Re: Petition No. 1585 - Endurant Energy petition for a declaratory ruling, pursuant to Connecticut General Statutes §4-176 and §16-50k, for the proposed construction, maintenance and operation of a 4.9-megawatt AC battery energy storage facility located at 508 North Colony Street, Meriden, Connecticut, and associated electrical interconnection

Enclosed for filing with the Connecticut Siting Council ("Council") are Endurant Energy's responses to the Connecticut Siting Council's September 26, 2023 interrogatories.

Interrogatory CSC 1

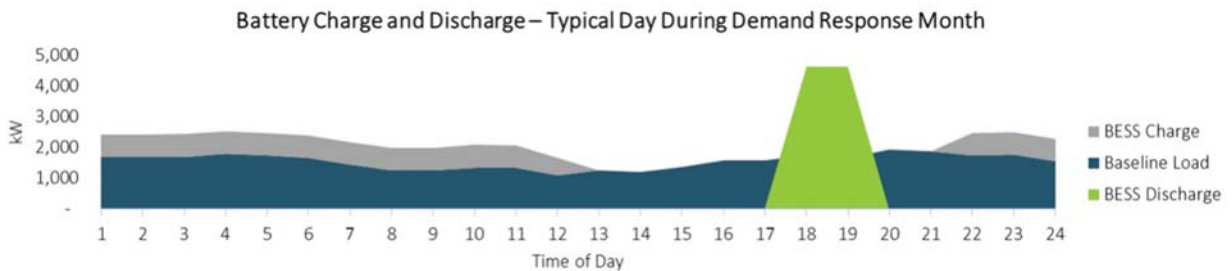
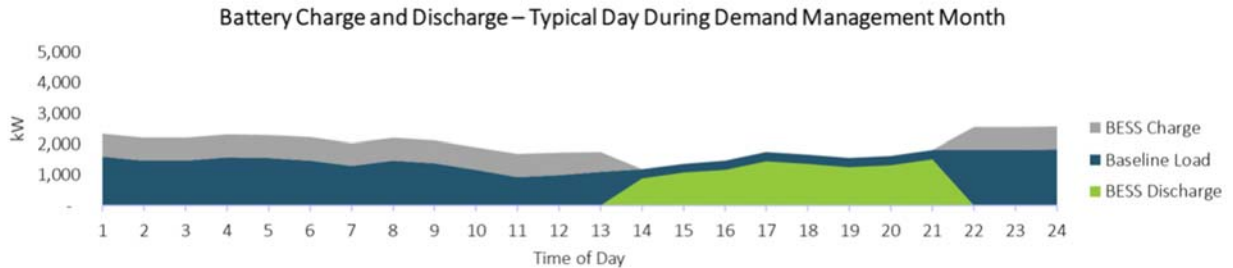
Q-CSC 11: What is the approximate percentage of Accel’s annual electric load that would be served by the BESF?

A-CSC 11: Because this is an energy storage system, and not an energy generation system, when the BESF serves Accel’s building, it will not 'off-set' a specific portion of Accel's overall load, but instead will 'shift' the load required to lower-priced 'off-peak' times from expensive peak times (when the battery will be discharged). This load shifting, or management, will occur year-round. See Demand Management graph below. During the summer months, from June 1 through September 31, the battery will be participating in the Energy Storage Solutions Program (ESS program). Again, it will charge during off-peak hours, but during the program's Performance Season, it will discharge as requested by the Program Administrators. See Demand Response graph below.

In terms of approximate percentages, the total annual consumption of Accel's facility with the battery is expected to be around 10,820 MWh, and the load that the battery will manage will be 2,200 MWh - approximately 20% served.

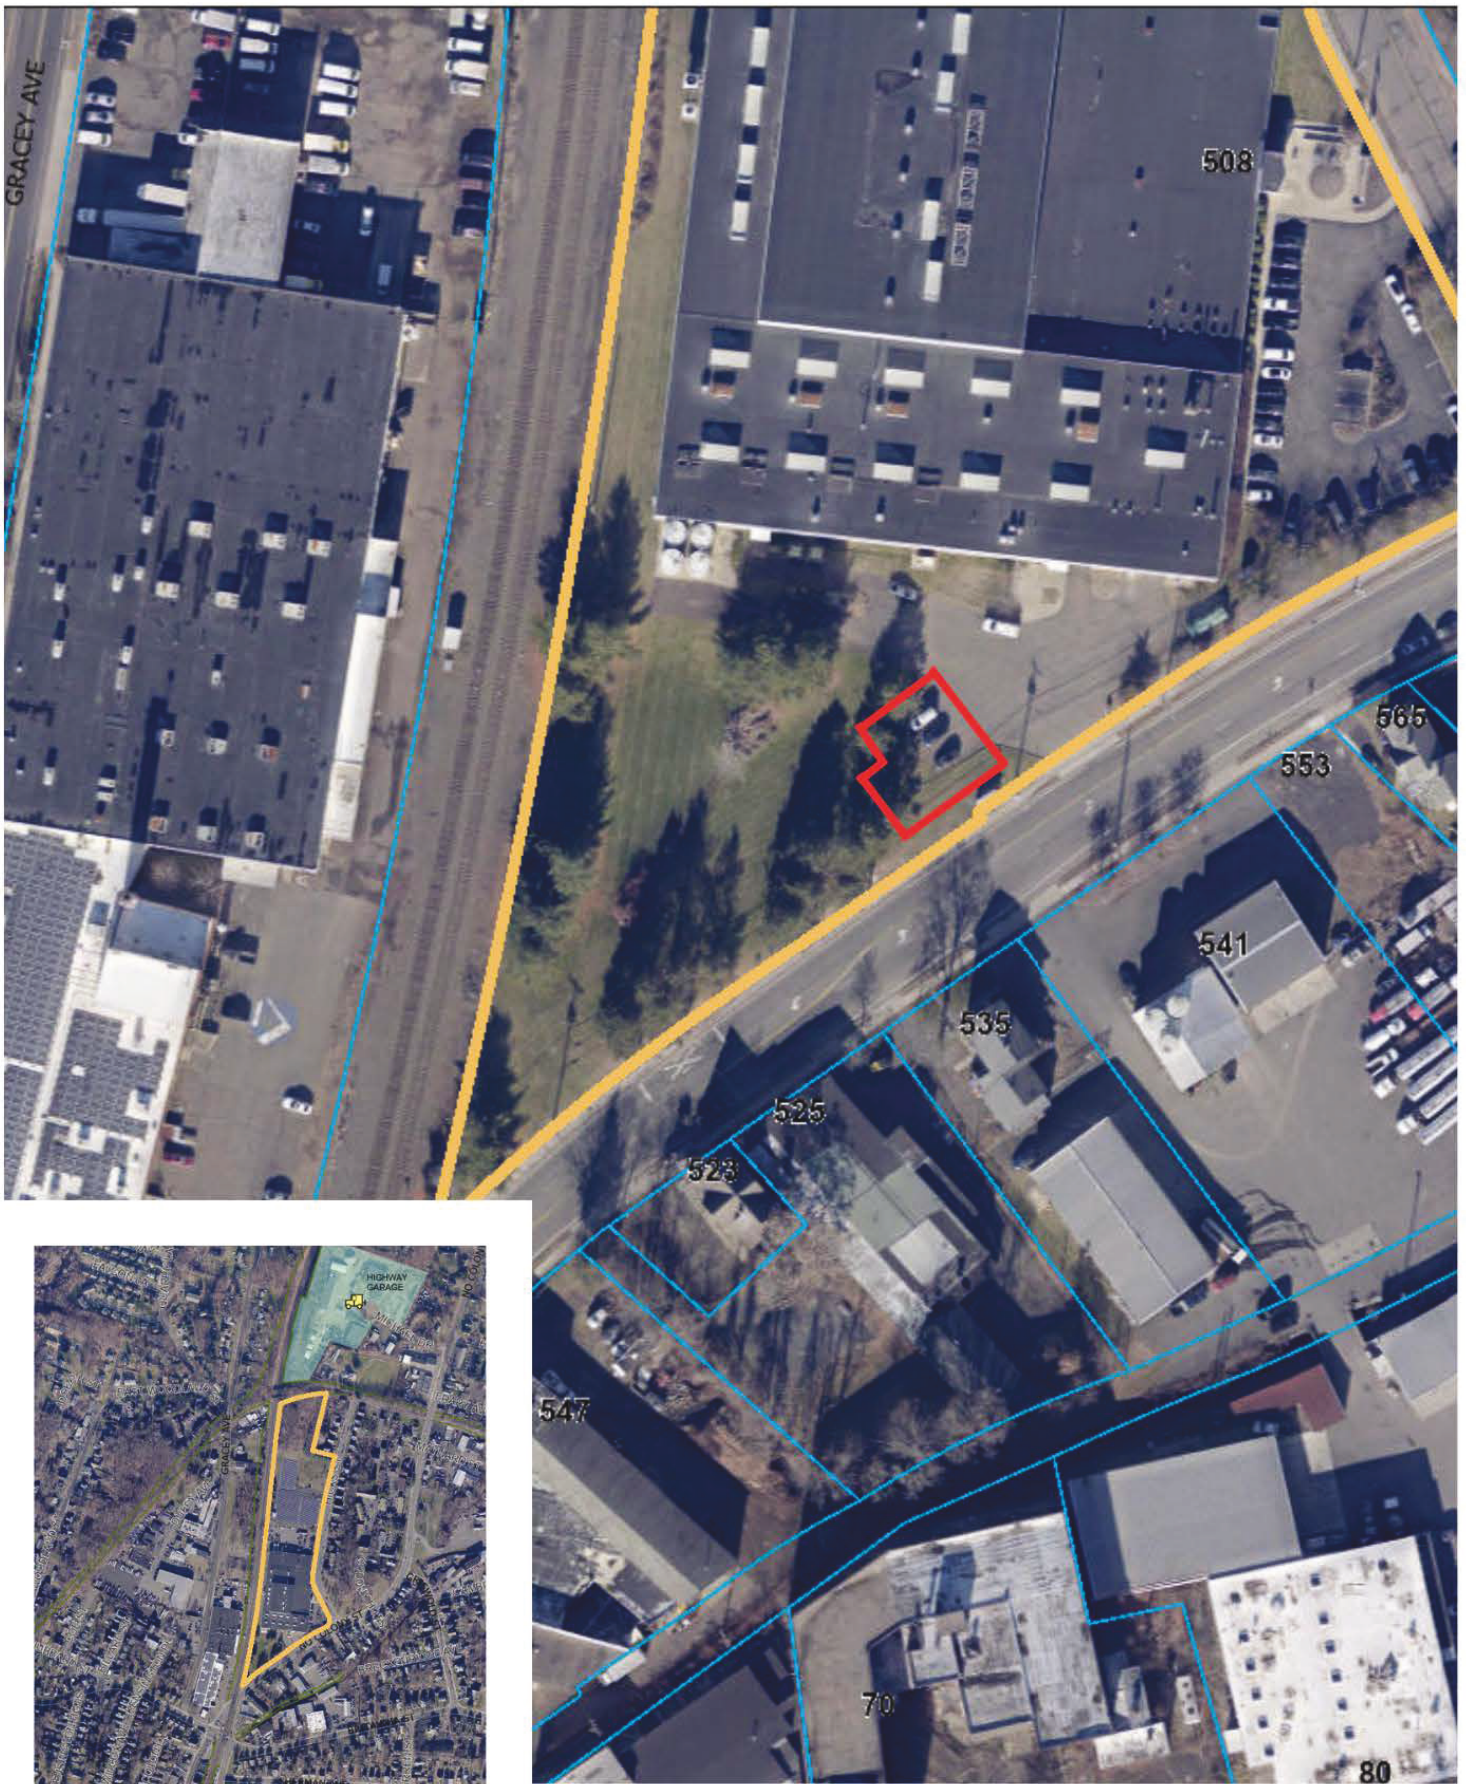
Q-CSC 57: Provide a decommissioning and site restoration plan.

Interrogatory #48  
Aquifer and Well Mapping

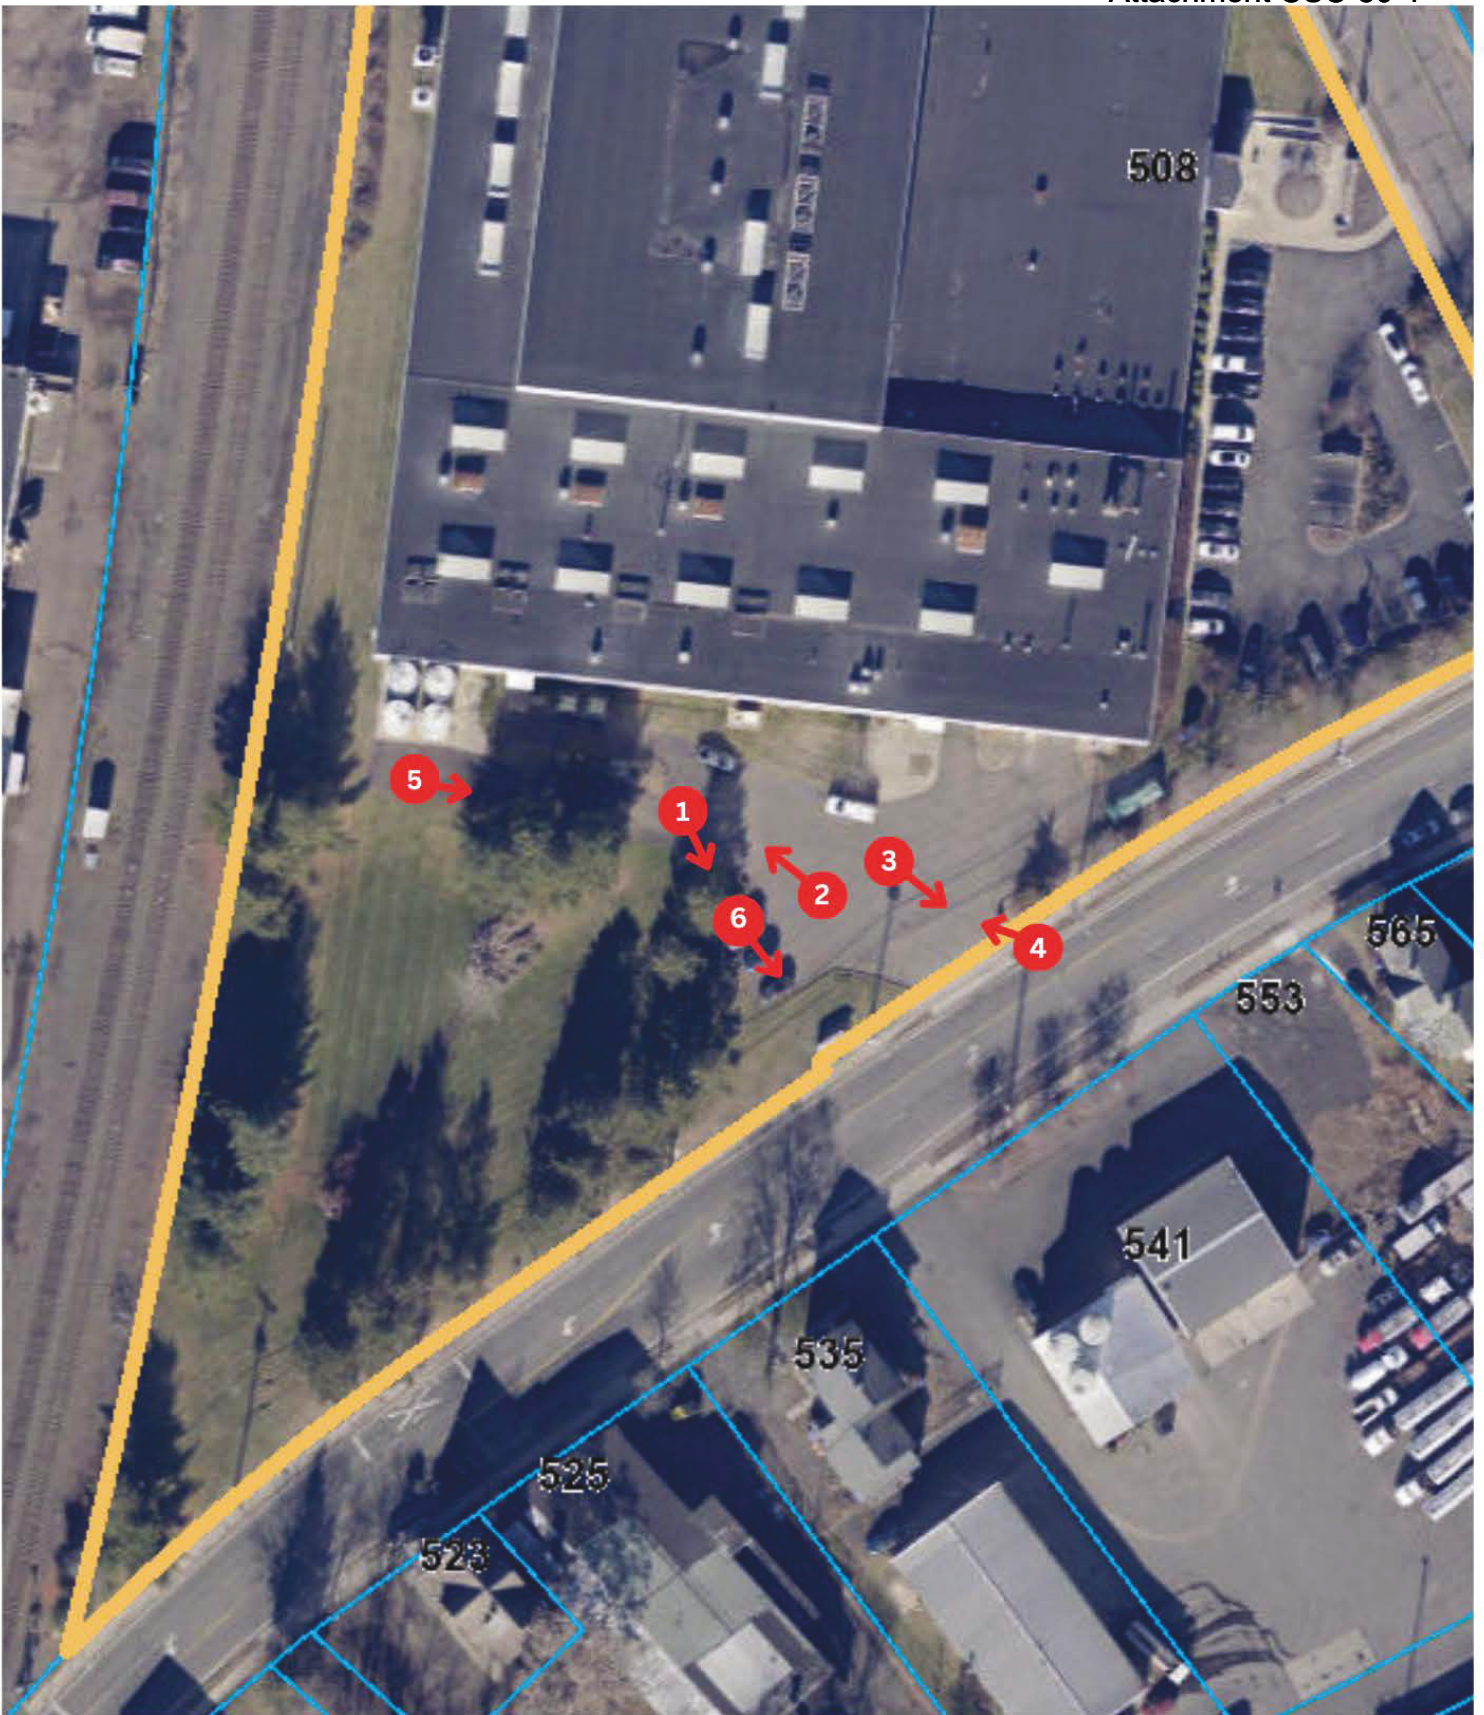
Q-CSC 48: Are there any wells on the site or in the vicinity of the site? If so, how would Endurant protect the wells and/or water quality from potential construction, operation and/or emergency response impacts?

A-CSC 48: There are no wells on the site. The closest well parcel is located approximately 1,755 feet from the project site. The closest aquifer protection area is approximately 750 feet from the project site, and well out of the influence of construction, operation and/or emergency response impacts. Please see Attachment CSC-48-1 developed using the Connecticut Drinking Water GIS Map Viewer.
